Preliminary Expert Witness Report

The Property of/Applicant:	Name withheld
Address:	Sample Property Suburb withheld Victoria
Insurer:	[company withheld]
Insurer Policy No:	&
Building Contractor:	Name withheld T/[company withheld] (ABN Sole Trader)
Building Permit No:	[permit withheld]
Site Inspection Details:	26 th November 2024 – 2:06PM

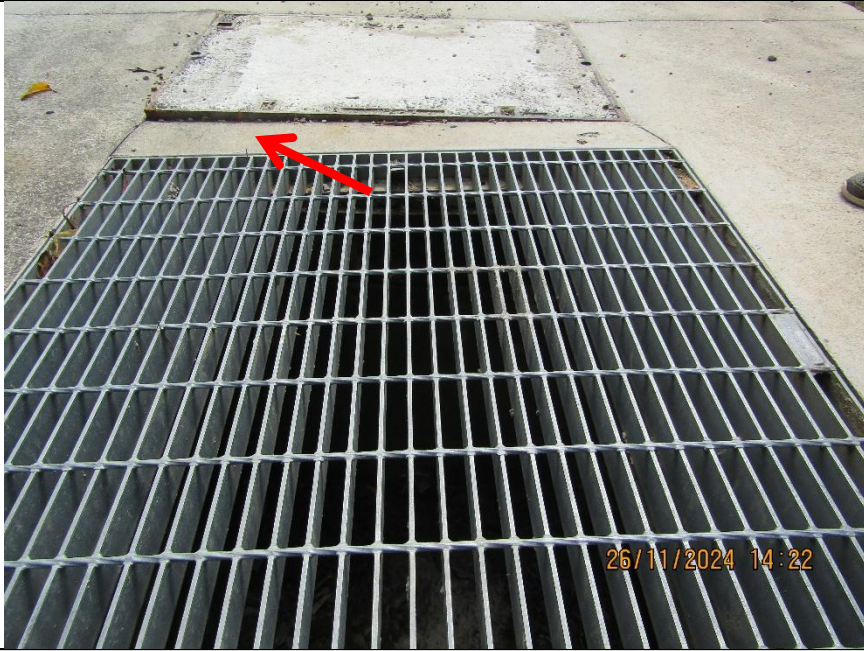
Photograph 12. shows the civil drainage storm water system and a compliant pit 4 with a 150mm drainage sub-surface pipe. This pit and staining debris around the pit indicate overflowing during heavy rain events.

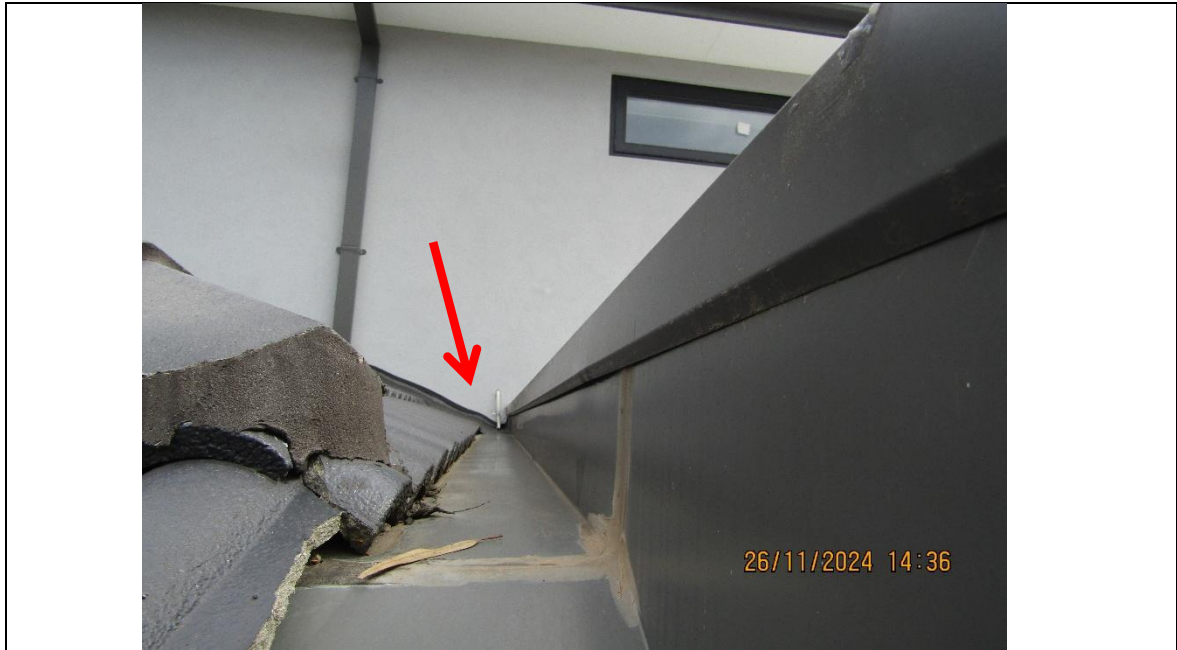
Photograph 18. shows the upper roof and roof drainage down pipe dispersing additional storm water onto the porch roof cover. This is non-compliant building work as the porch was not designed to take the rain water from the upper roof. This also contravenes the hydraulic design of the roof.
